<b>Title of Change:</b>	ON Suzhou's DPAK and IPAK Case Outline Change from Non-JEDEC to JEDEC Standard.
<b>Proposed first ship date:</b>	19 June 2019
<b>Contact information:</b>	Contact your local ON Semiconductor Sales Office or <Jinman.Song@onsemi.com>
<b>Samples:</b>	Contact your local ON Semiconductor Sales Office or <PCN.samples@onsemi.com> Sample requests are to be submitted no later than 30 days from the date of first notification, Initial PCN or Final PCN, for this change.
<b>Additional Reliability Data:</b>	Contact your local ON Semiconductor Sales Office or <Lake.Wang@onsemi.com>
<b>Type of notification:</b>	This is a Final Product/Process Change Notification (FPCN) sent to customers. FPCNs are issued 90 days prior to implementation of the change. ON Semiconductor will consider this change accepted, unless an inquiry is made in writing within 30 days of delivery of this notice. To do so, contact <PCN.Support@onsemi.com>

**Table 1: Old vs New Comparison for DPAK dimension.**

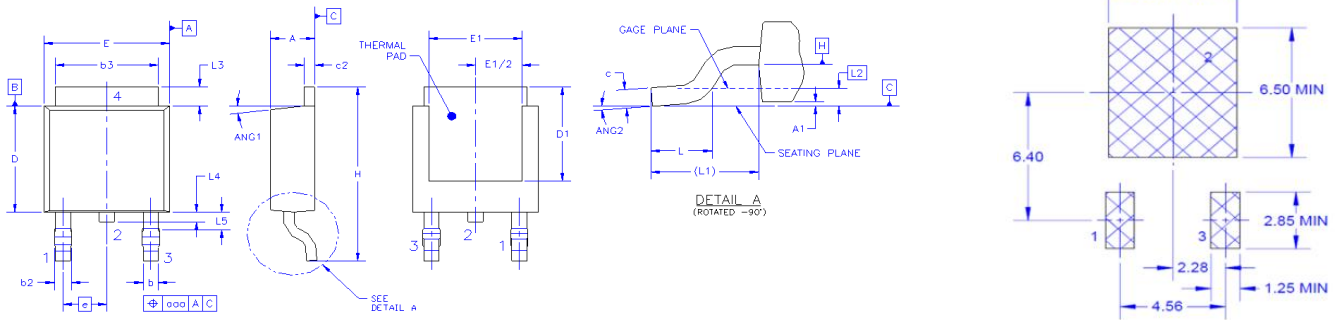
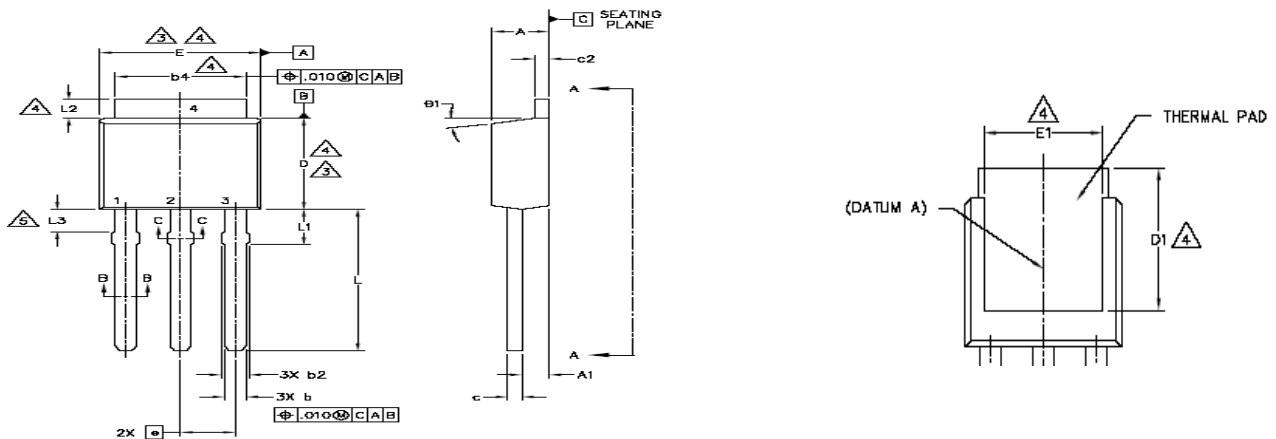
REF	DESCRIPTION	Old Dimension (DPAK NON-JEDEC)			New Dimension (DPAK JEDEC)		
		MIN	NOM	MAX	MIN	NOM	MAX
A	Package thickness	2.20		2.40	2.18	2.29	2.39
A1	Profile height	-0.050		0.20	---		0.127
b	Lead width	0.66	0.76	0.86	0.64	0.77	0.89
b2	Dambar cutting width			0.96	0.76	0.95	1.14
b3	Heat sink width	5.04	5.34	5.64	5.21	5.34	5.46
c	Lead thickness	0.40	0.50	0.60	0.45	0.53	0.61
c2	Heat sink thickness	0.40	0.50	0.60	0.45	0.52	0.58
D	Package length	5.900	6.10	6.30	5.97	6.10	6.22
D1	Back metal length	4.83			5.21		---
E	Package width	6.40	6.60	6.80	6.35	6.54	6.73
E1	Back metal width	5.040	----	5.640	4.32		---
e	Lead pitch	2.08	2.28	2.48	---	2.29	BSC
H	Total package length	9.20	9.50	9.80	9.40	9.91	10.41
L	Foot length	1.40	----	1.70	1.40	1.59	1.78
(L1)	Lead length	2.50	2.70	2.90	2.9ref		
L2	Gage plane	0.490	0.50	0.510	---	0.51	BSE
L3	Heat sink height	0.50		0.90	0.89	1.08	1.27
L4	Center lead cut length	----	----	----	0.64	0.83	1.02

L5	Dambar distance to pkg edge				---	---	---
ANG1	Package draft angle	----	----	----	---	---	---
ANG2	foot landing angle	----	----	----	0.00	---	10.00
aaa	Lead position tolerances	---	---	---	---	---	0.25
